To: Jack Thompson (NRW)
From: Royal HaskoningDHV
Date: 07 April 2025
Copy: Arndt Hermann (MHPA)
Our reference: PC1477-RHD-ZZ-ZZ-FN-EV-0003
Classification: Project related
Checked by: Gregor McNiven

Subject: Milford Haven Port Authority Jetty Improvements (Application Number: CML2484): Further Information Request Response

Figure 1 Relationship between SPL (dB re 1 μ Pa²s) and distance for impact piling (Nedwell et al., 2003b)

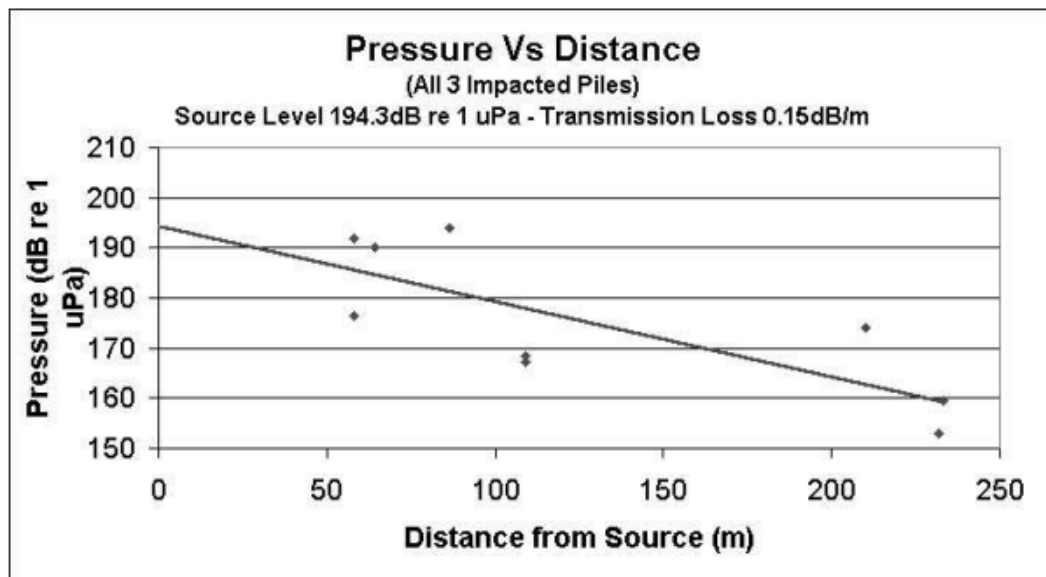
No assessment has been completed to quantify the impact and severity of impact from underwater noise to marine mammals. To fully assess the impact on marine mammals, additional information is required in relation to disturbance and injury from underwater noise.

Additionally, sound generated is expected to reduce with distance from the piling. As part of the study for the Red Funnel Terminal in Southampton, Nedwell et al. (2003a) identified a 0.15 dB reduction in SPL per metre from the source (see Figure 1). While other factors may affect this, a similar reduction is anticipated at Port Authority Jetty, reducing the potential for disturbance impacts to marine mammals that could be present within the vicinity of piling works.
